Official Transcript of Proceedings
NUCLEAR REGULATORY COMMISSION

Title: Advisory Committee on Reactor Safeguards
Subcommittee on the Westinghouse AP1000
DCD and Vogtle Units 3 and 4 COL

Date: Thursday, June 24, 2010

AP1000 Containment

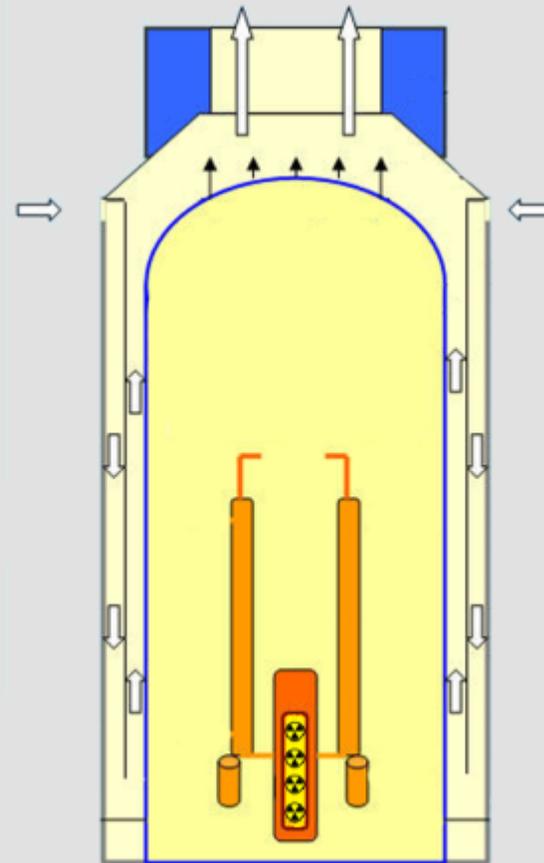
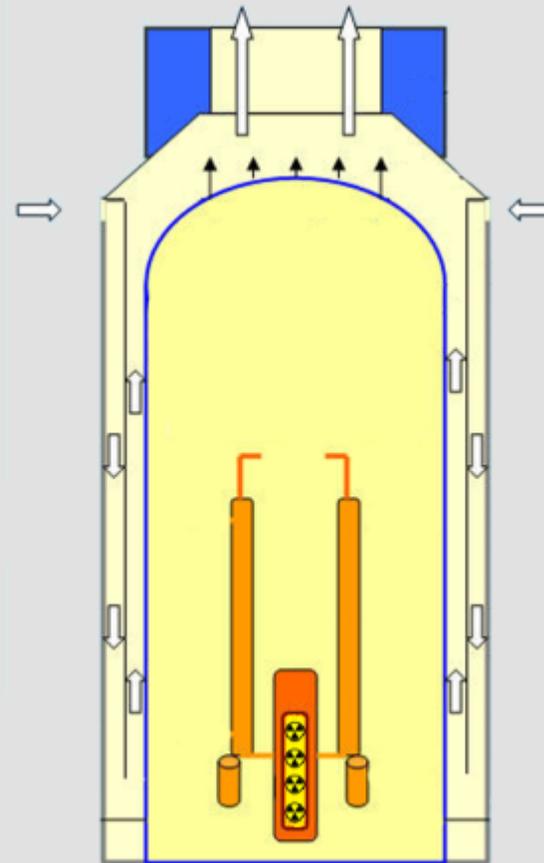
During the AP1000 review, the staff expressed concerns about corrosive attack on the AP1000 containment. In response to concerns from the NRC in 2003, Westinghouse made the containment 1/8th inch thicker and added a nuclear-grade protective coating. The AP1000 has access ports to allow for visual examination of some portions of the outside of the containment.

“The staff noted there was no margin in the nominal design thickness for corrosion allowance.”

ASME XI inspection programs have historically missed flaws in the containment.

Application of protective coatings has historically allowed for coating degradation.

Wall-brackets on the outside of the AP1000 containment create crevices that allow for moisture build-up and creates a corrosive environment.

The junction between the wall and the floor creates a crevice that allows for moisture build-up and creates a corrosive environment.

AP1000
Chimney Effect
Draws
Radioactivity
Directly Into The
Environment

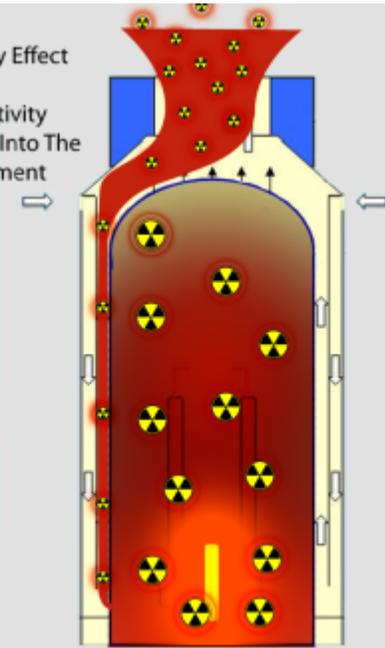
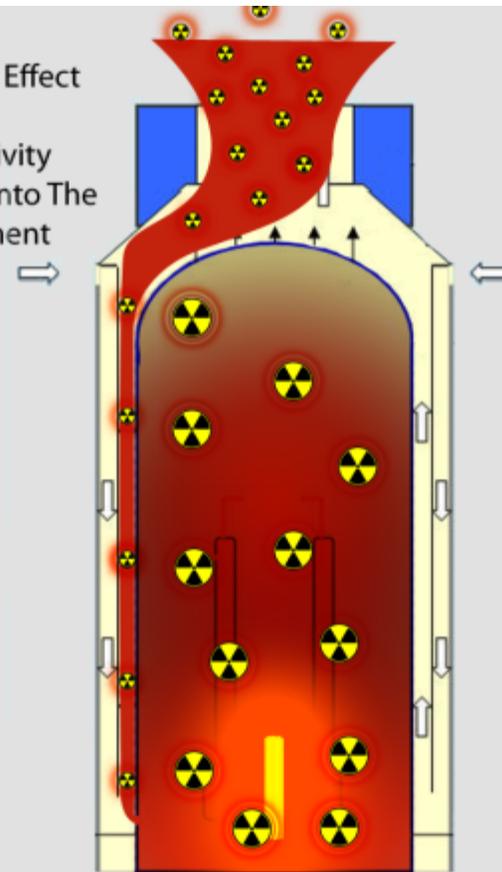
For its SAMDA analysis, Westinghouse assumes a late containment failure (CLF), a failure of the containment to isolate (CI), and bypass through an open piping system (BP).

For the CLF, CI, and BP scenarios, Westinghouse assumes that containment leakage is into other filtered areas of the plant and is not released directly into the environment.

AP1000
Chimney Effect
Draws
Radioactivity
Directly Into The
Environment

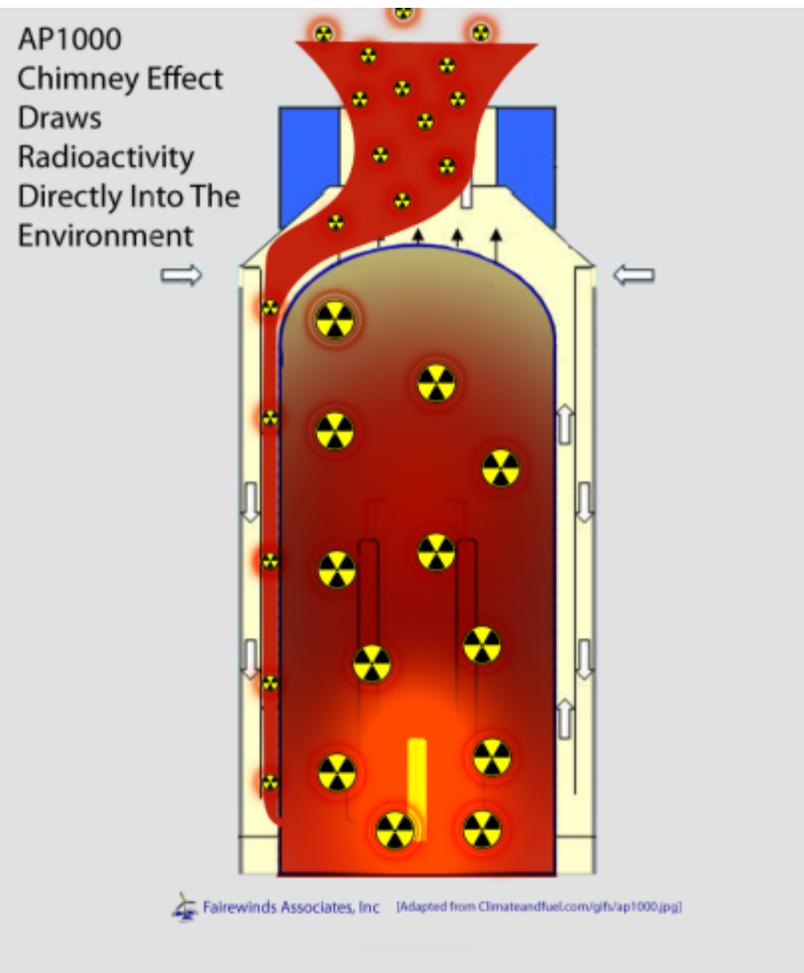
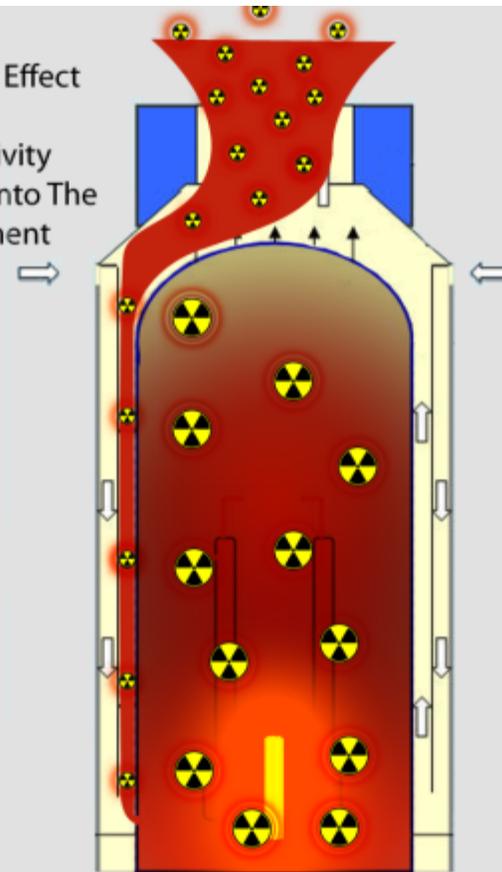
Both Westinghouse and the NRC assume that ASME XI inspections and protective coatings applied to the outside of the AP1000 containment will reduce the risk of a pinhole leak to **ZERO**.

Fairewinds analysis of 40-years of problems associated with the integrity of containment shows there is a relatively high probability of a pinhole leak in the AP1000 containment.

Should this pinhole leak exist, post accident pressures of 50-psi inside the containment will push radioactive gases into the annular gap causing off-site doses to exceed 10 CFR 100 allowable exposure levels.

Even this proposed option does not completely eliminate Fairewinds’ concerns as leakage into the annular gap through a pinhole leak in the containment wall might not be captured.
